Site Address:
2 Kingfisher Close,
Kirkby,
L33 4DP

Drawing Title:
Proposed Isometric Views

Project No:	Drawing No:	Scale @ A1	Revision:
25.009	104	1 : 50	P01

Existing 3D View 1

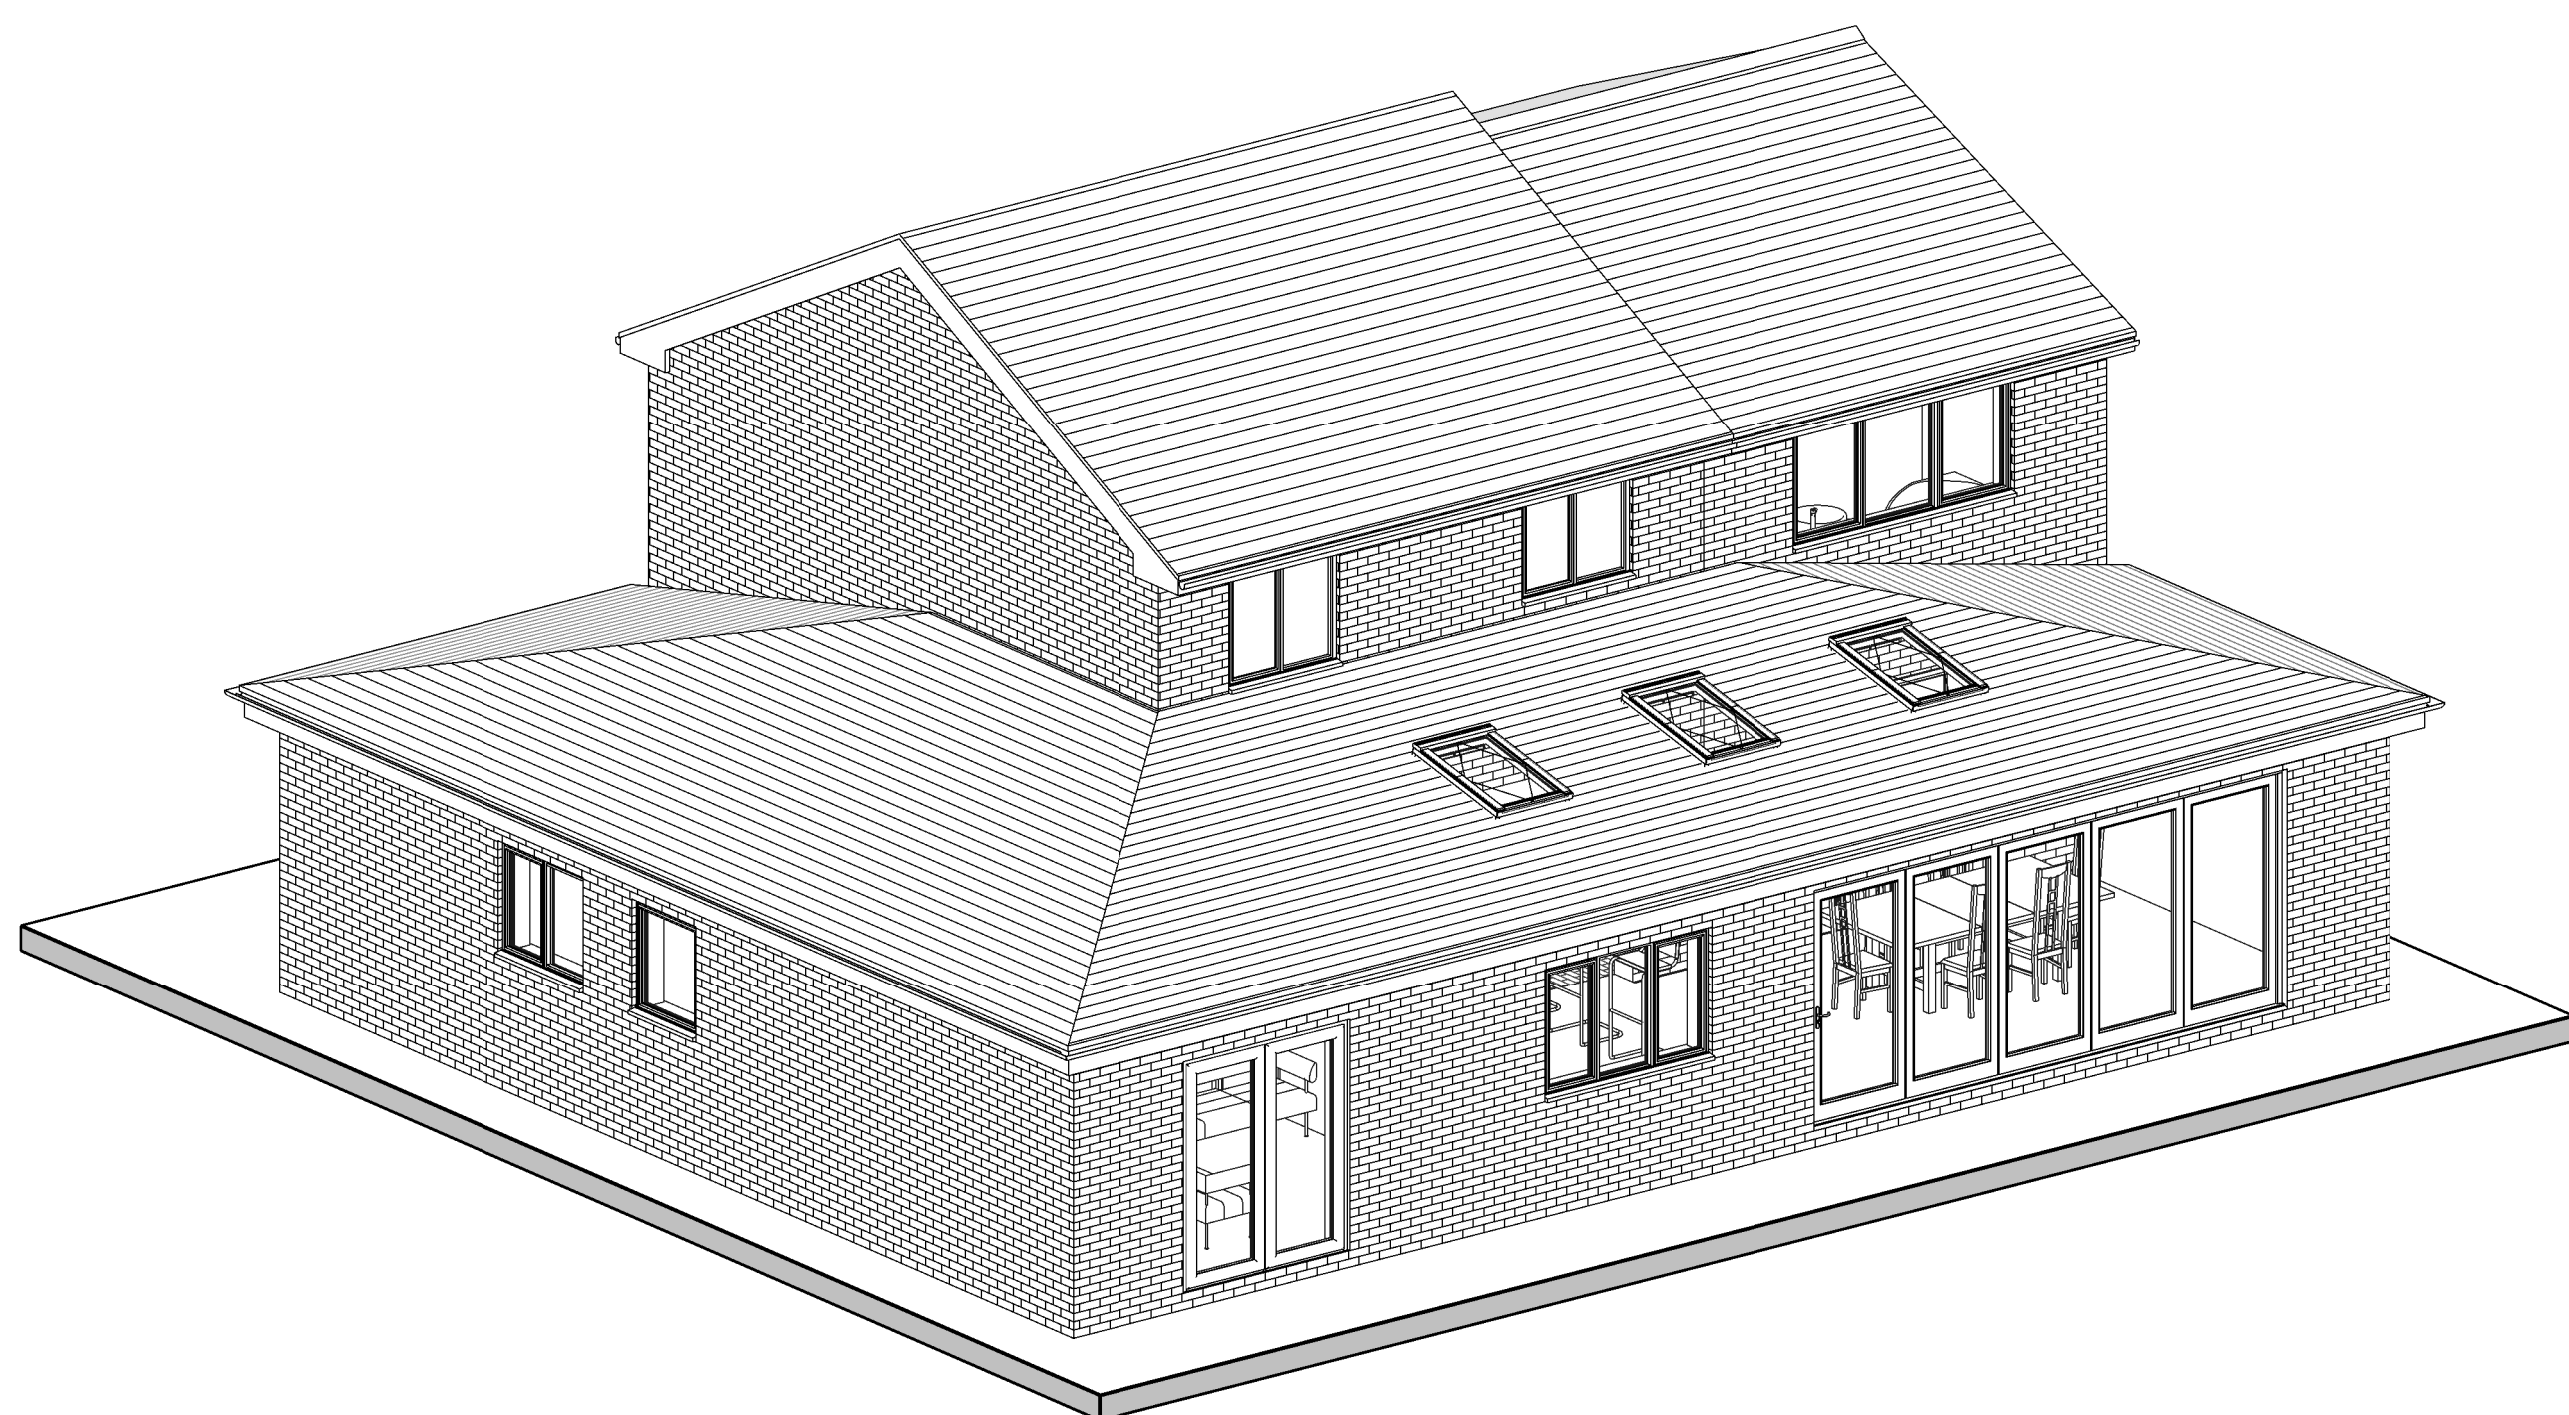
Rev	Description	Date
P01	Juliet balcony added to the (south-facing) side elevation. Submitted to Planning as a Non-Material Amendment application. Revised as clouded.	13.02.2026
